STAFF RECOMMENDATION

NCPC File No. 6479

**PATENT OFFICE BUILDING
CANOPY AND COURTYARD LANDSCAPE**
G, F, 7th and 9th Streets, NW
Washington, DC

September 1, 2005

OPTION 2: COURTYARD VIEW OF CANOPY

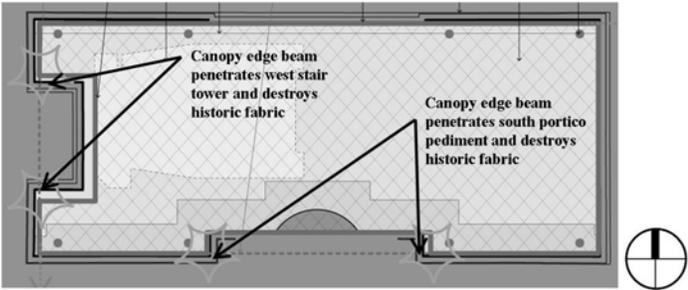
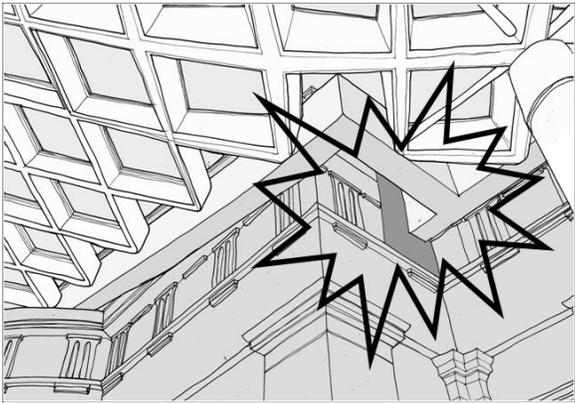
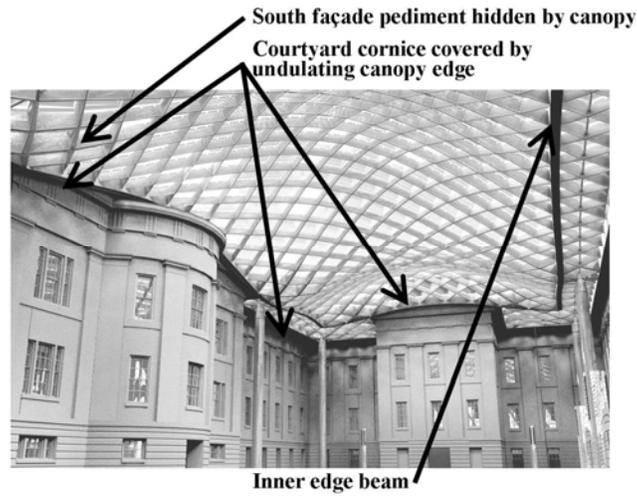
Option 2 is not recommended because the canopy edge beam would penetrate the west stair tower and south façade pediment and destroy historic fabric. The undulating canopy edge would visually interrupt and intrude upon the courtyard facades by covering portions of the architectural frieze and cornice and creating awkward junctures. Furthermore, the canopy would obscure the south façade pediment as viewed from the courtyard.

OPTION 3: COURTYARD VIEW OF CANOPY

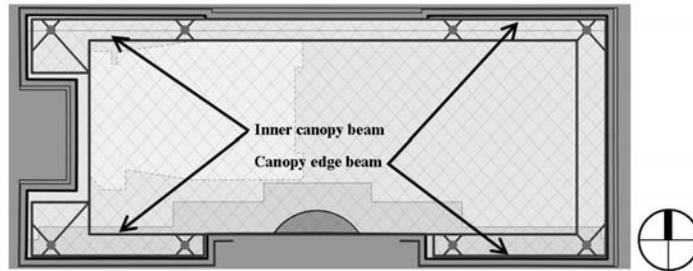
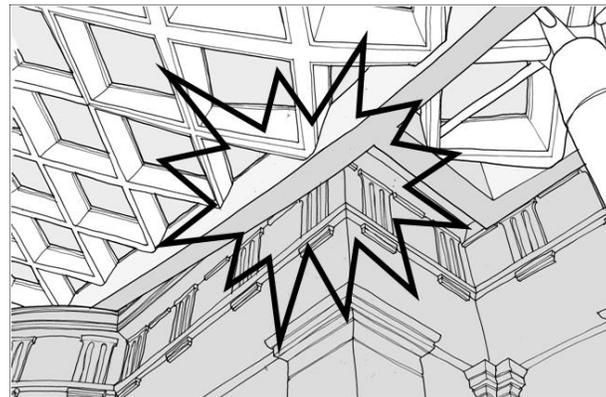
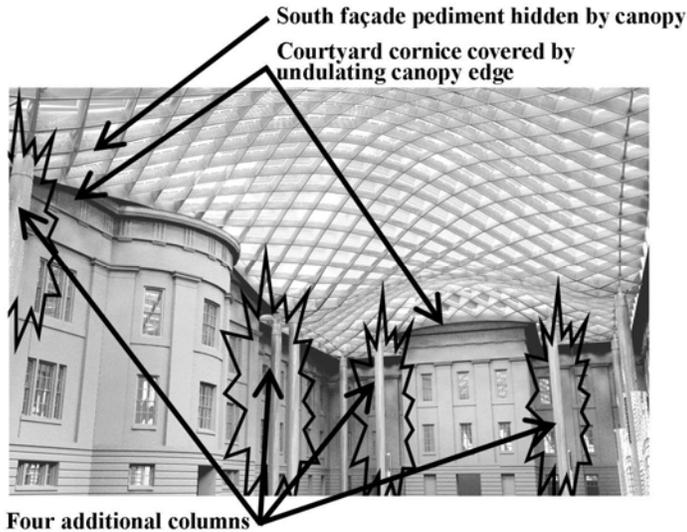
Option 3 was the only possible alternative to Option 1, in staff's judgment, but is not recommended. Option 3 would incorporate an inboard structural beam running through the canopy grid in order to avoid penetrating the historic building fabric. Additional canopy and perimeter beams would also be required. However, Option 3 is not recommended because the canopy edge would visually interrupt and intrude upon the frieze and cornice of the courtyard facades and obscure the south façade pediment, as in Option 2.

OPTION 4: COURTYARD VIEW OF CANOPY

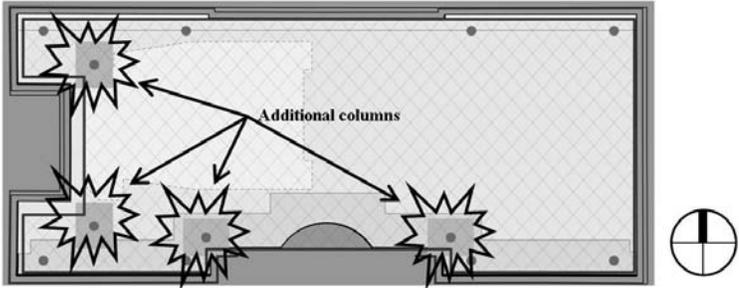
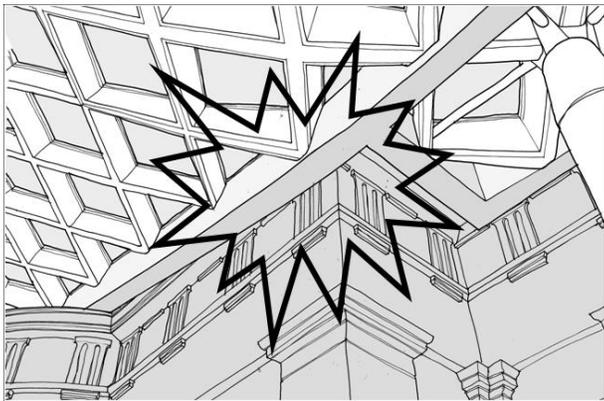
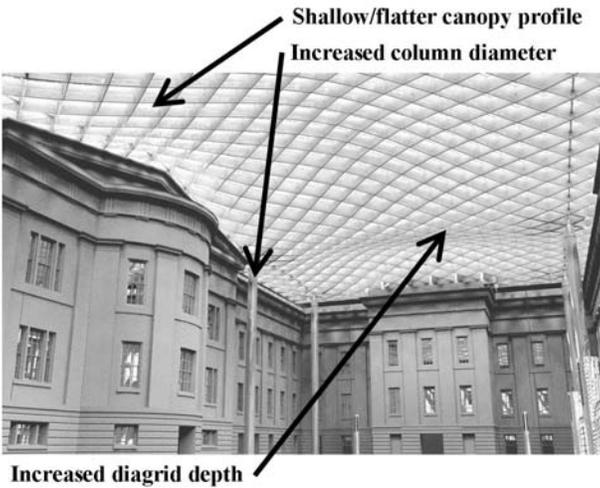
Option 4 is not recommended because the canopy edge would visually interrupt and intrude upon the frieze and cornice of the courtyard facades and obscure the south façade pediment, as in Options 2 and 3. It would also require four additional columns, two flanking the west stair tower and two flanking the south façade projection, which would intrude upon the courtyard space.

OPTION 5: COURTYARD VIEW OF CANOPY

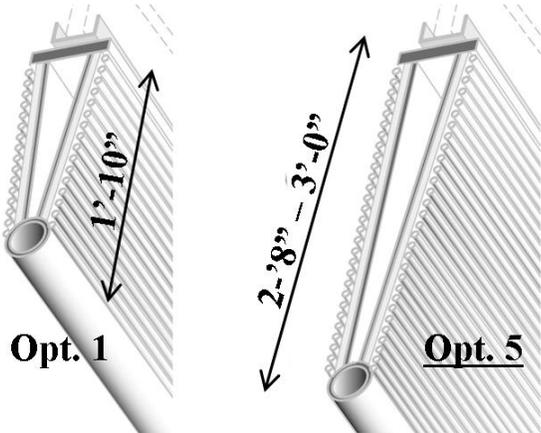
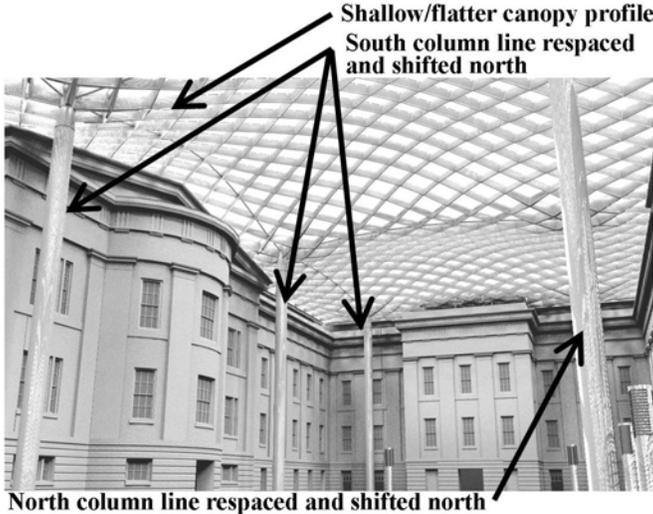
Option 5 would flatten the canopy profile and elevate it so that it would not obscure the south façade pediment and courtyard façade cornices. However, Option 5 is not recommended because the canopy grid structural depth would be increased from 22 inches (in the proposed canopy, Option 1) to 34-36 inches, thereby reducing incoming daylight in the courtyard and views of the sky through the canopy. The reduced daylight would also reduce options for courtyard plant materials. The column diameter would be increased from 38 inches to 42 inches.

OPTION 6: COURTYARD VIEW OF CANOPY

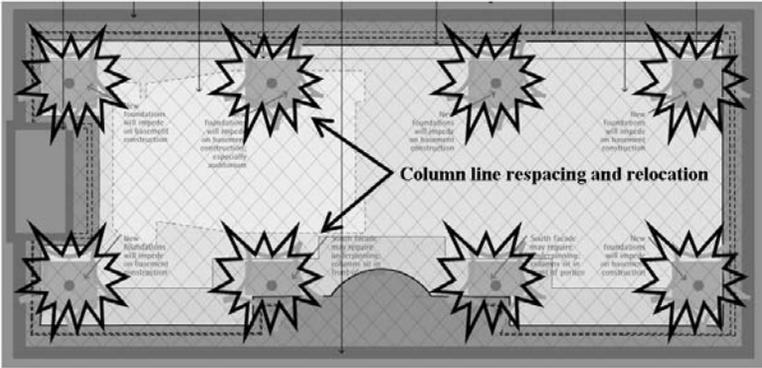
Option 6 would flatten the canopy profile and elevate it so that it would not obscure the south façade pediment and courtyard façade cornices. All of the columns would be relocated and spaced equidistantly in order to help reduce the structural long spans. However, Option 6 is not recommended because of the awkward placement and intrusion of the columns in the courtyard space.

PROPOSED COURTYARD BALCONY

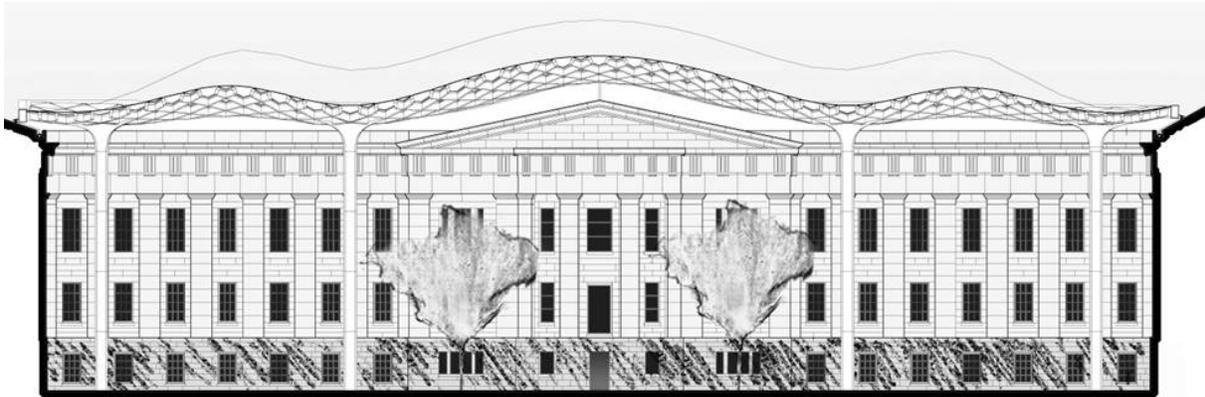
Staff strongly recommends against the inclusion of a balcony in the design. The structure would become an additional projecting form in the courtyard where the two original projections – the semicircular south stair projection and the western stair tower – should be the dominant forms in front of the four courtyard walls that create a balanced and harmonious neoclassical composition of windows, pilasters, and cornices. The balcony would not only create a foreign appendage and mass in front of the north courtyard façade that would interrupt and obscure the visibility of the façade, but it would require the removal of historic fabric to create a door, an alteration that should be avoided. Altering the second level window to become a balcony door is an extreme measure that should not be undertaken. Further, the relationship and balance of the courtyard facades and the three-dimensional space they contain would be unnecessarily altered in a manner inconsistent with the Secretary’s Standards and with the Commission’s June 2005 direction “to rehabilitate its prior design character and setting.”

PROPOSED SOUTH FAÇADE LANDSCAPE PLANTINGS

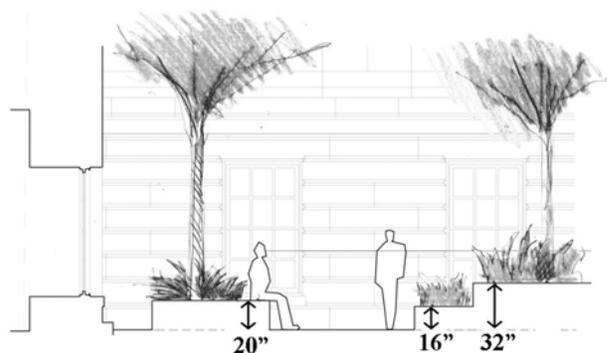
Staff recommends against the trellis of continuous plant materials proposed for installation in front of the first floor of the south courtyard façade. All of the courtyard facades should be seen in their entirety, since they gain their significance from being understood as a whole and from defining the courtyard space. The desired green softening of the courtyard to counteract the new floor should be achieved in the ground plane rather than on the historic walls. The south façade is unique because it is constructed of Aquia sandstone and has a strong pediment, an additional reason for not obscuring the façade in any respect. The staff's objections arise from the same concerns stated for the balcony and the reflective applications. The greenery would obscure an important part of the façade and adversely affect the appearance of the original historic façade and character of the courtyard setting.
